**Re: Westport Waterfront - Buffer Management Plan (BMP)**

**Re: Westport Waterfront - 10% Phosphorus Reduction Calculations and  
Buffer Management Plan (BMP), Phase I**

**Re: Westport Waterfront - 10% Phosphorus Reduction Calculations**

DRAWING NO.  
DP-1  
SHEET NO.  
1 of 4

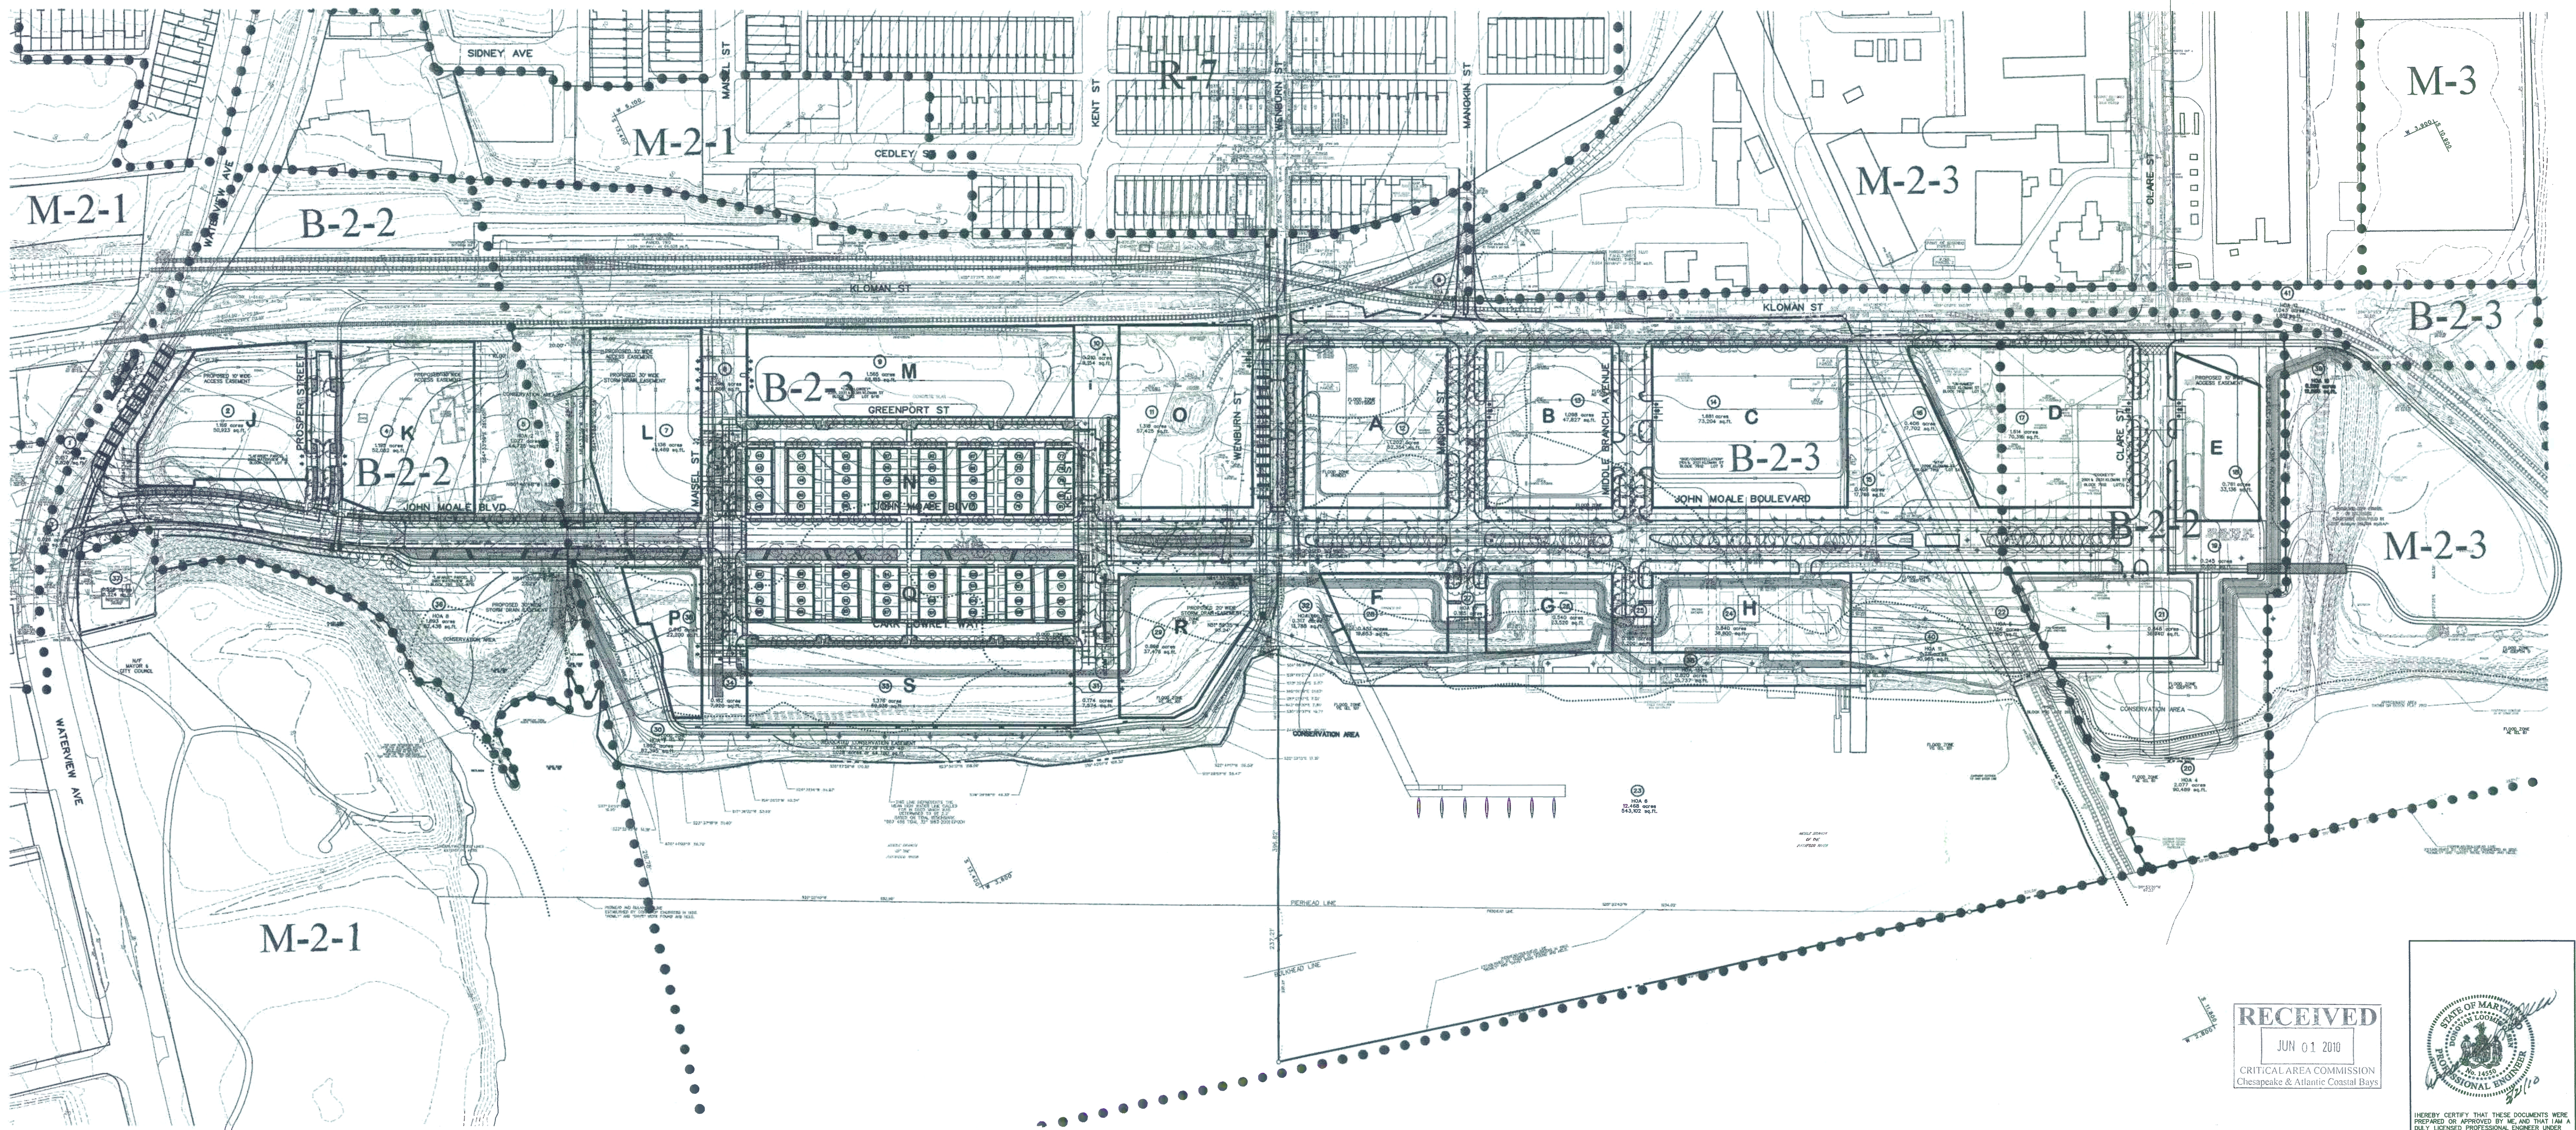
Link to BMP?
